HISTORIC DISTRICT COMMISSION
STAFF REPORT

5:30 pm • April 22, 2019 • City Hall

OLD CONWAY DESIGN OVERLAY DISTRICT NEW COMMERCIAL ACCESSORY BUILDING 1915 HARKRIDER STREET

**OLD CONWAY DESIGN OVERLAY DISTRICT
PORCH ADDITION
524 FAULKNER STREET**

Applicant provided sketches

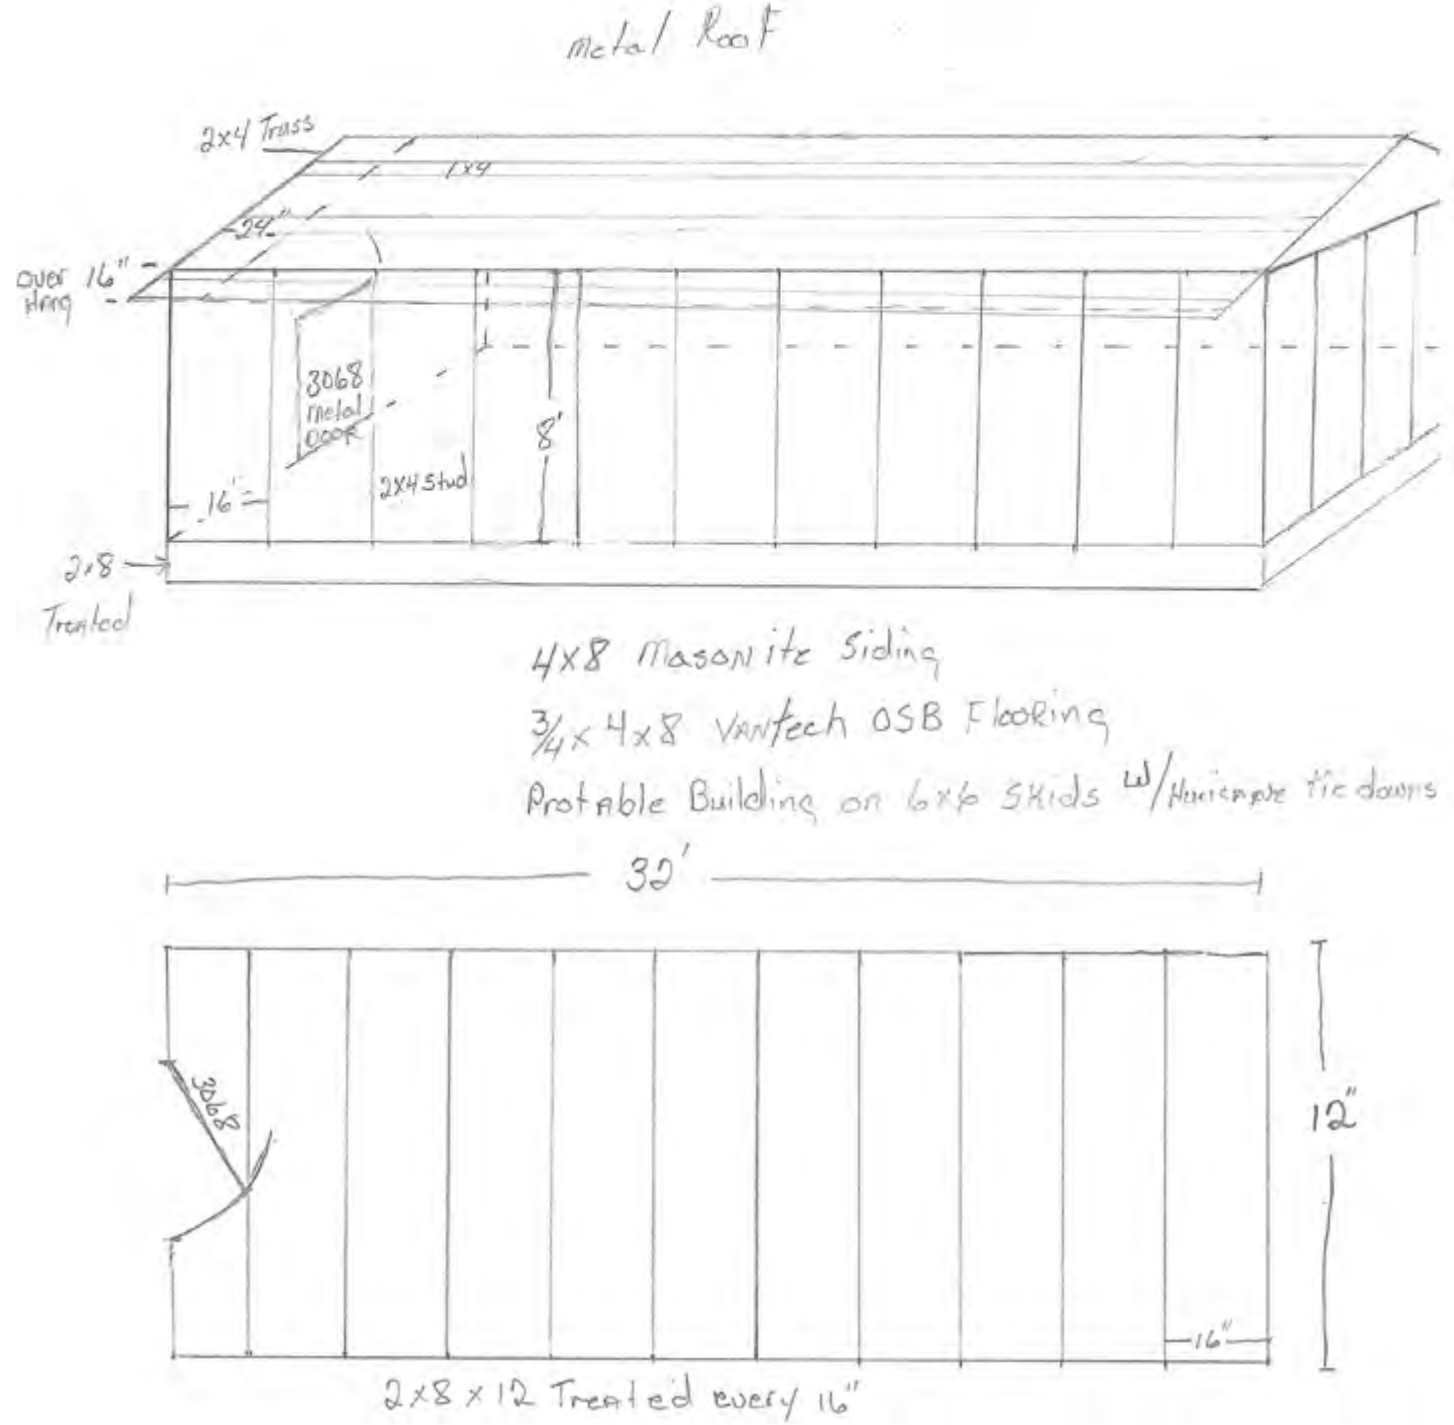
General Description of Property and Proposed Development. The site is home to a showroom for a fireplace installation/service business. The applicant is proposing to construct a new 12' X 32' portable commercial accessory structure. The structure will be clad with Masonite siding and have a corrugated metal roof.

The rear setback will be 15' to the rear and 23' to the side. The outbuilding will set at the side of the structure, as the site has little to no room behind the principal structure.

The structure is proposed to have a metal roof. There does not appear to be a historical basis for the use of this type roof.

The applicant is proposing to use Masonite siding which should be considered appropriate. The structure is not proposed to be constructed on a foundation.

1. The proposed construction is generally inconsistent with the design standards for the district. The structure's location at the side of the structure, metal roofing, as well as its lack of a foundation are key reasons for this lack of consistency with the standards.
2. The applicant should alternately consider constructing an addition to the primary structure.

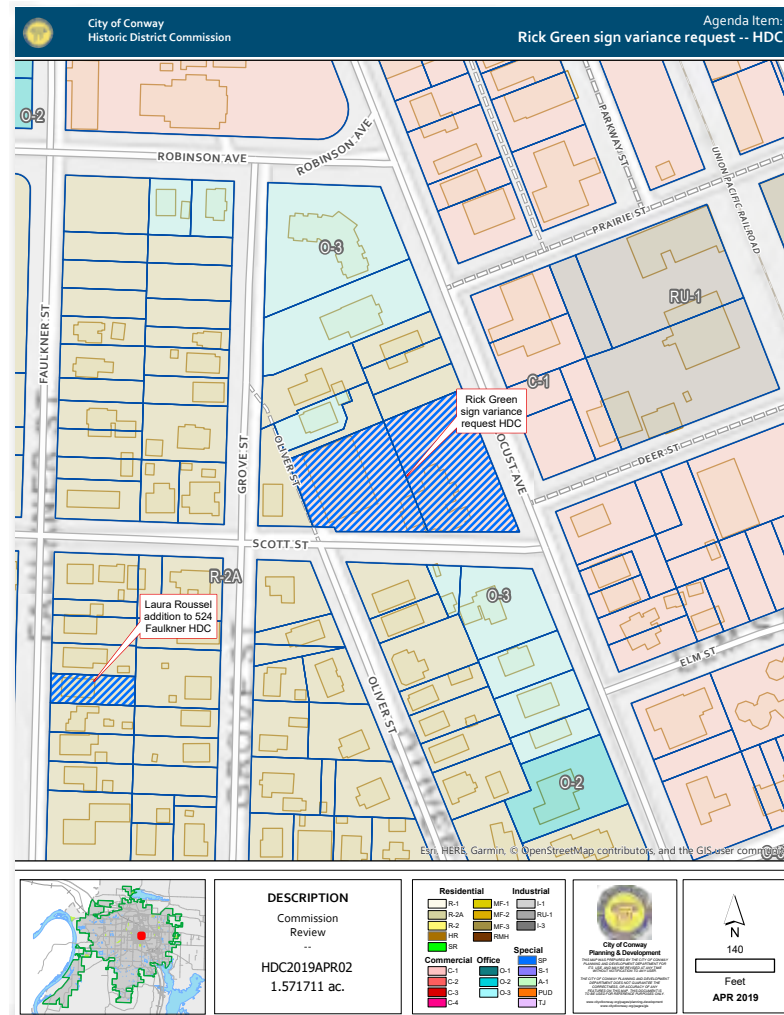
General Description of Property and Proposed Development. The applicant is proposing to construct a new two-pole freestanding sign in front of a converted historic home and parking lot that is now used as an office building. The proposed sign is 49.2 square feet in size with 24.5 square feet devoted to sign surface area and will be externally illuminated. The proposed sign is 49.2 square feet in size with 24.5 square feet devoted to sign surface area and will be externally illuminated.

Signage. Freestanding signs are not otherwise permitted in C-1 zones. All freestanding signs in the Old Conway Design Overlay District should not exceed 16 square feet in size and 4 feet in height.

There are numerous signs in the area which are larger than 16 square feet. However, this sign would likely be one of the larger signs along the corridor.

1. Reduce the height of the sign to 56". (This will effectively reduce its size to 37 square feet).
2. The applicant will provide revised plans to the Planning Director for review and approval prior to issuance of sign permits.

Site Plan (Sowell Architects)

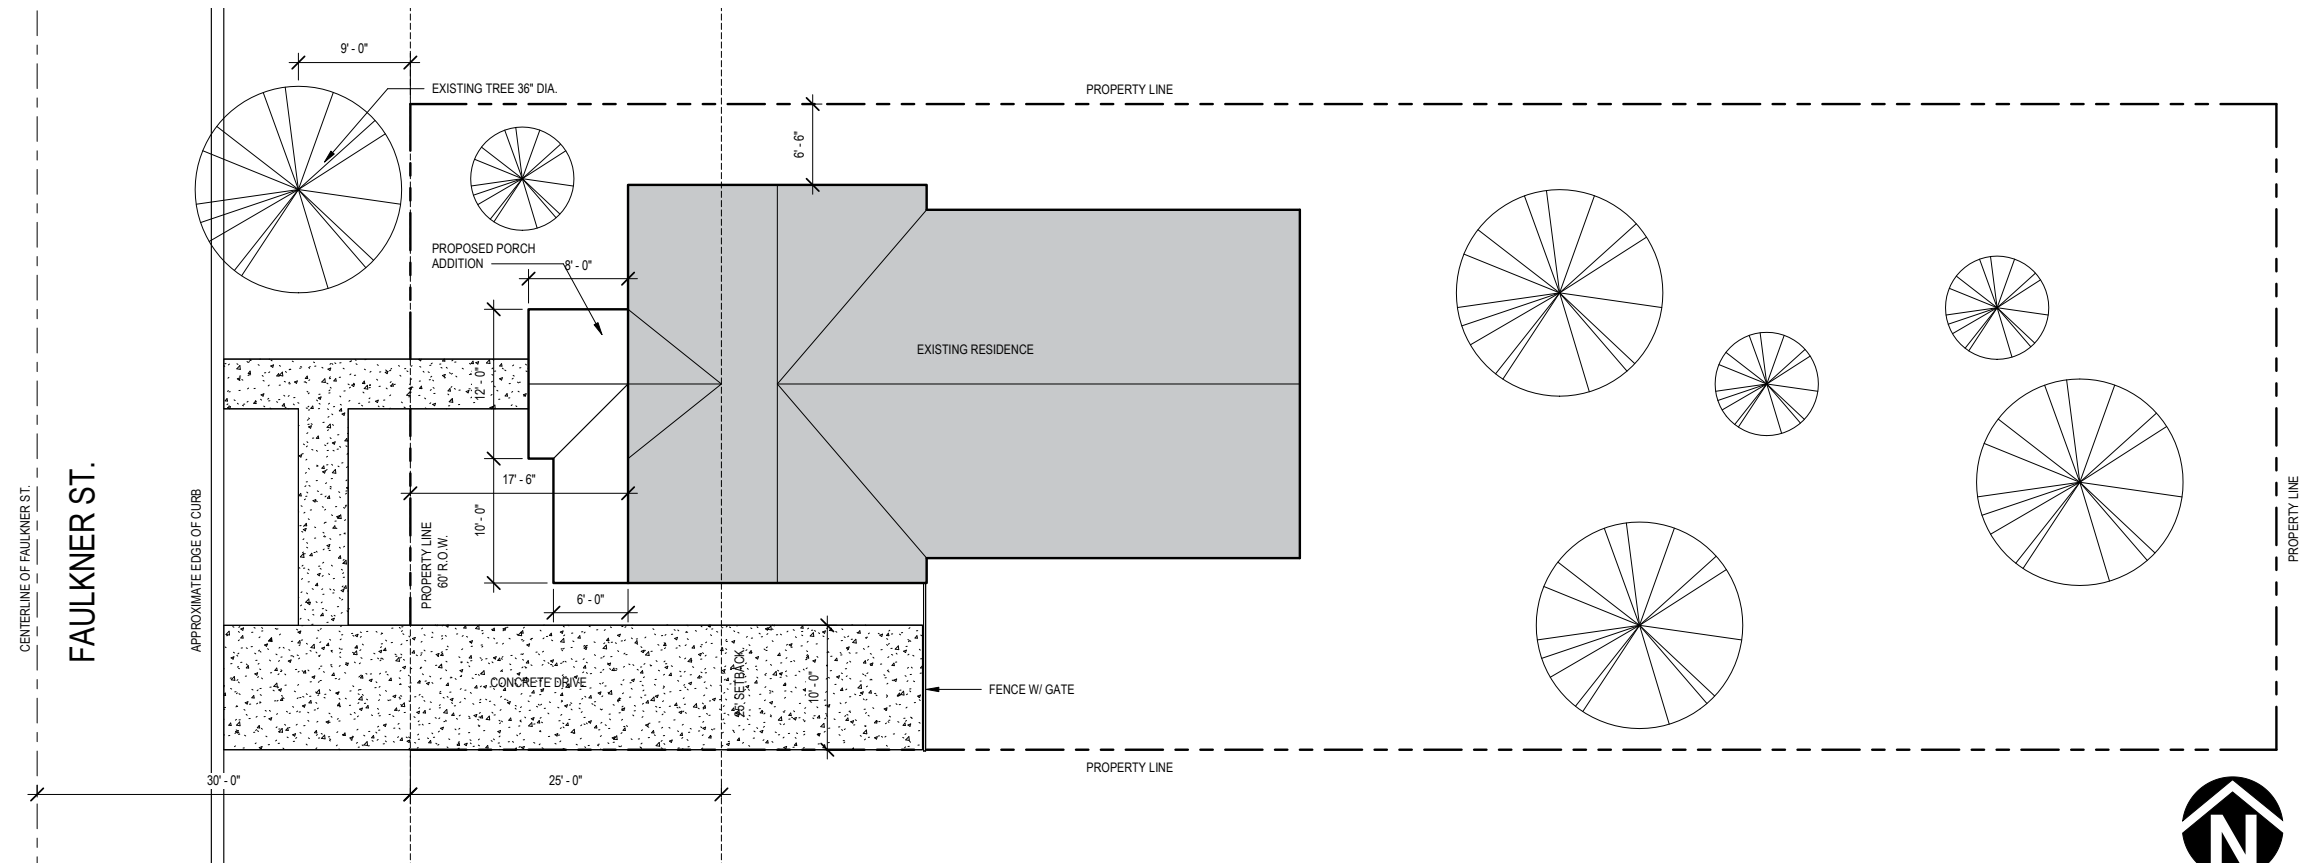
Setbacks and Spacing. Front setbacks are allowed within a range of 85% to 115% of the average front setback of the area. The average setback from the property line for the area is 16.75', based on the four adjacent properties to the north and south. The included drawings indicate an existing setback of 17.5'. The porch addition would reduce the setback to 9.5'. The other existing setbacks conform to the zoning requirements.

The proposed setbacks are not appropriate.

Driveway / Parking. The applicant is proposing a 10' driveway adjacent to the south property line. Existing gravel parking exists in front of the front door.

If a sidewalk is constructed, it should be placed at the back edge of the right-of-way. The current proposed location is not appropriate.

No additional tree plantings are required. The existing Sycamore tree shall be required to be retained.

1. Driveway shall be paved with asphalt, concrete, or appropriate pervious pavers.
2. The addition shall be constructed with wood or hardie board, as appropriate.
3. HVAC equipment be placed in a manner to minimize its visibility from the street.
4. If constructed, the sidewalk shall be placed at the back edge of the right-of-way.
5. The applicant will provide revised plans to the Planning Director for review and approval prior to issuance of building permits.

Applicant provided sketch (Sowell Architects)

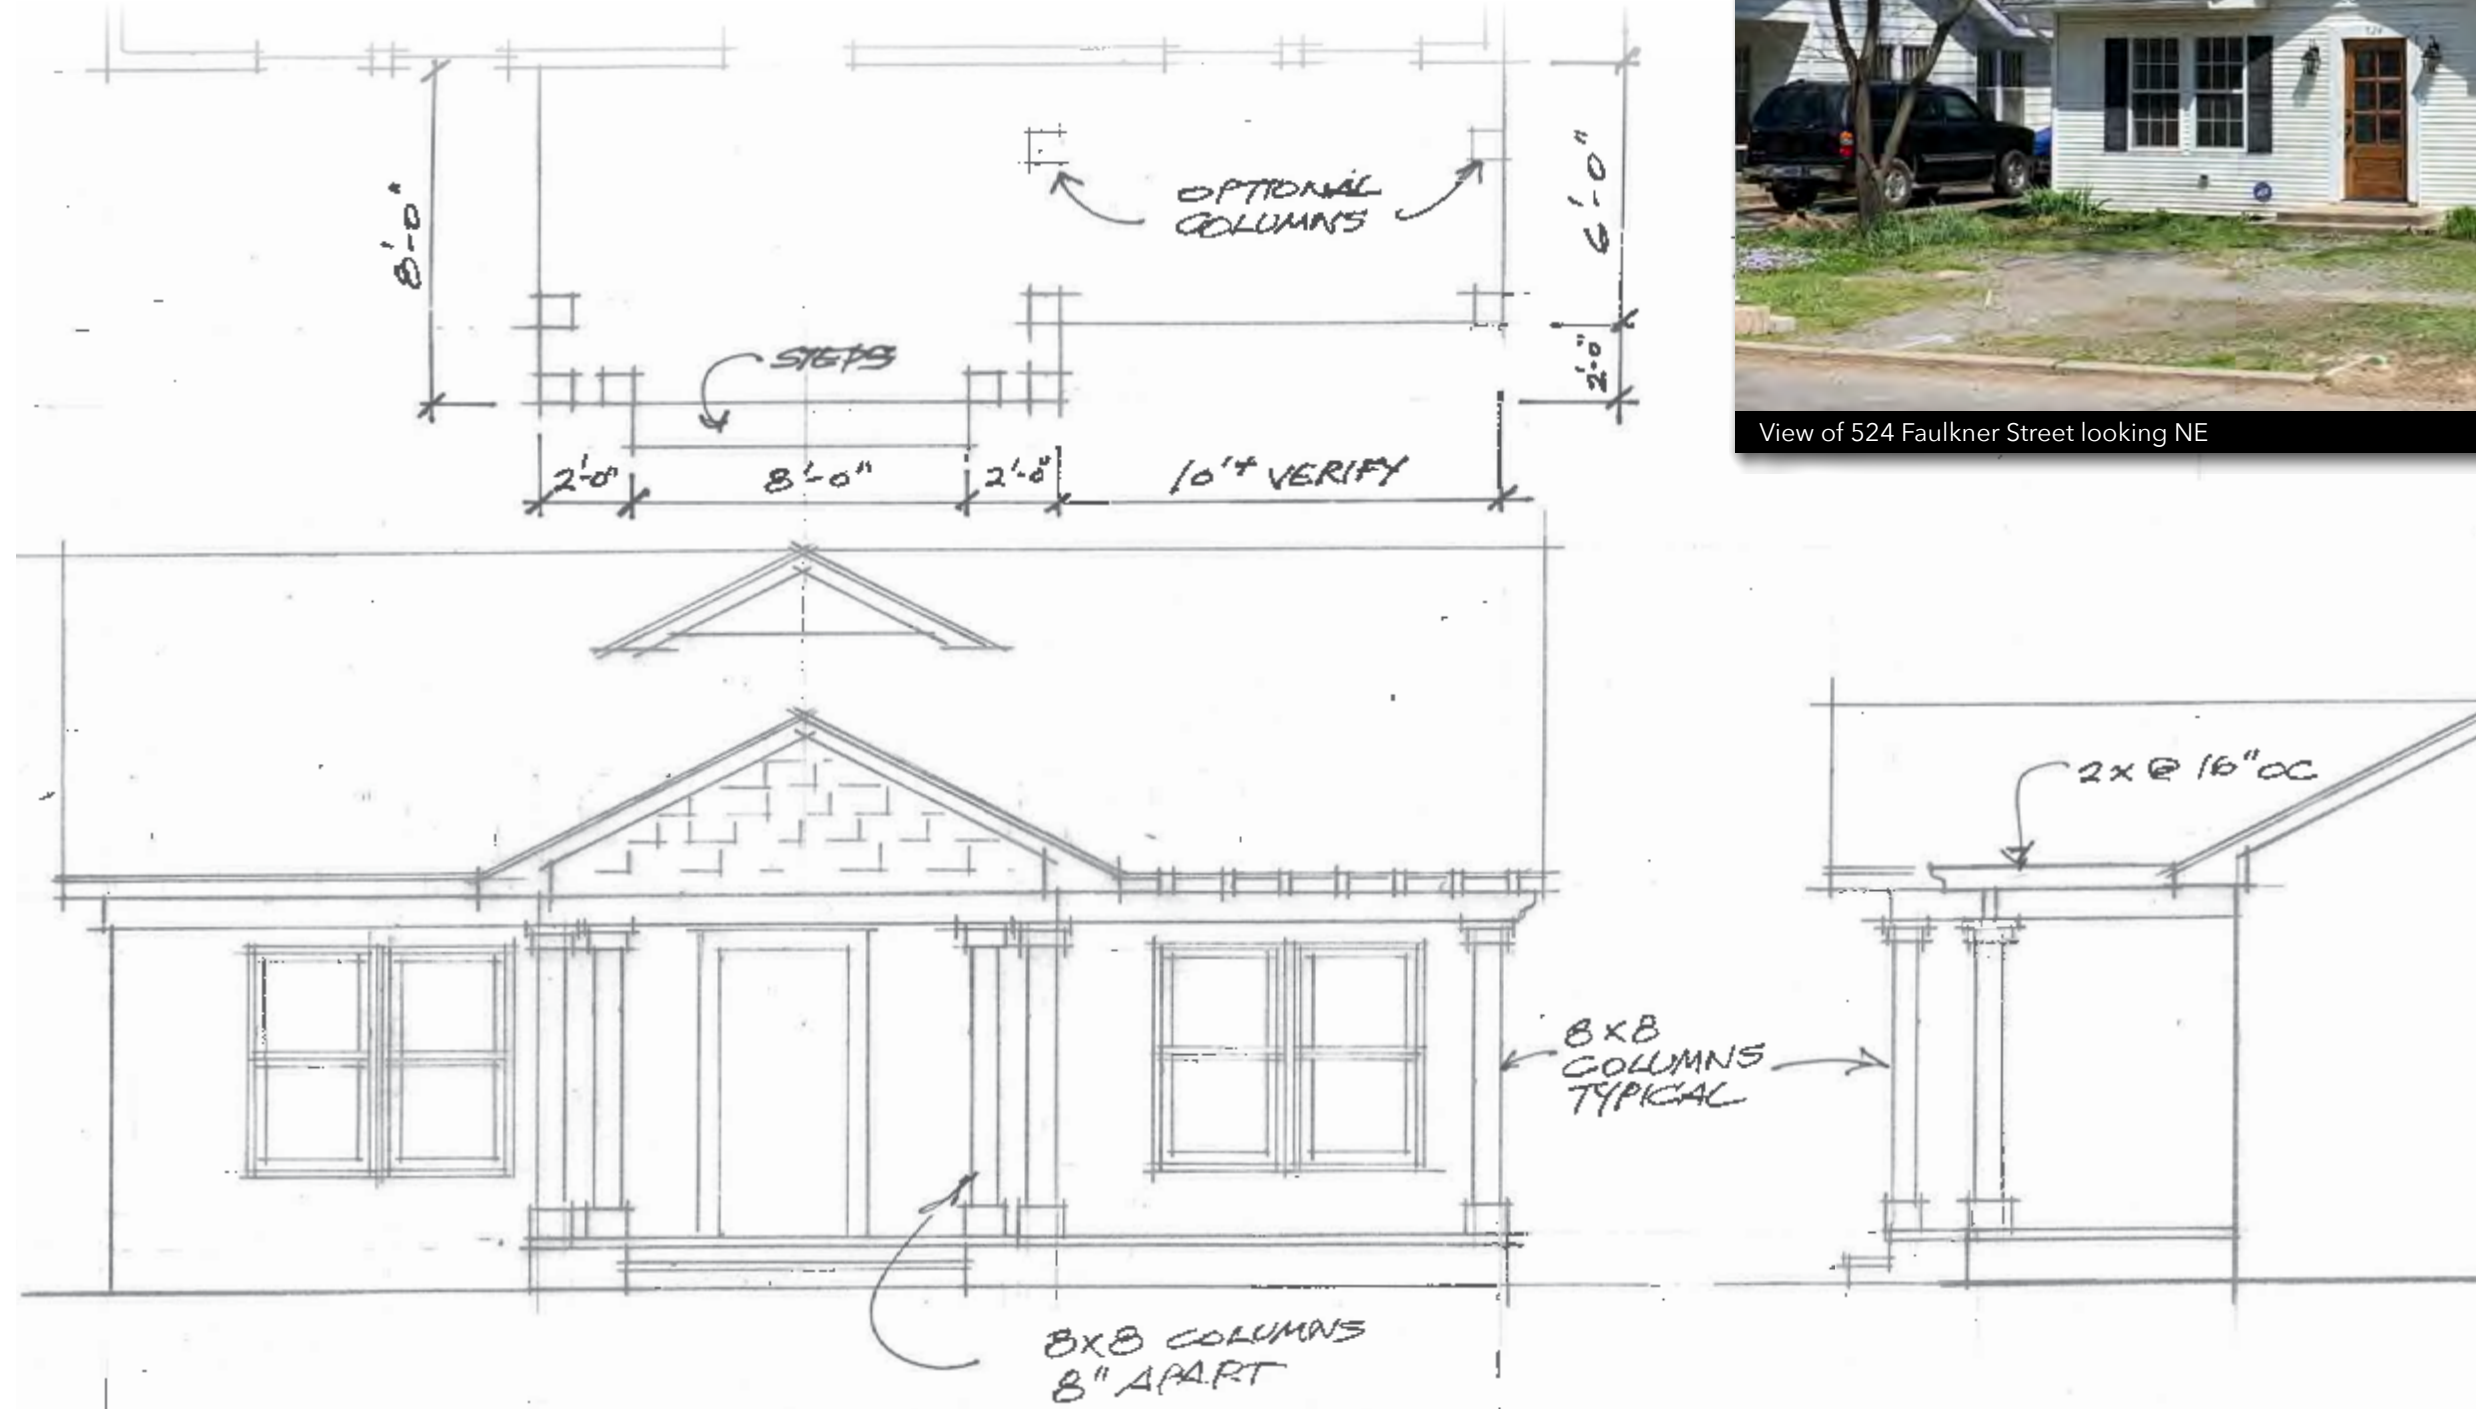
The proposed porch will be between 6-8', with the covered portions at 8' deep. The roof form will complement the structure. The proposed columns will help frame the entryway.

Detailing and materials are uncertain from the application. Staff recommends minimum requirements be imposed as a condition of approval. This would include requirements for the use of wood or Hardie board.
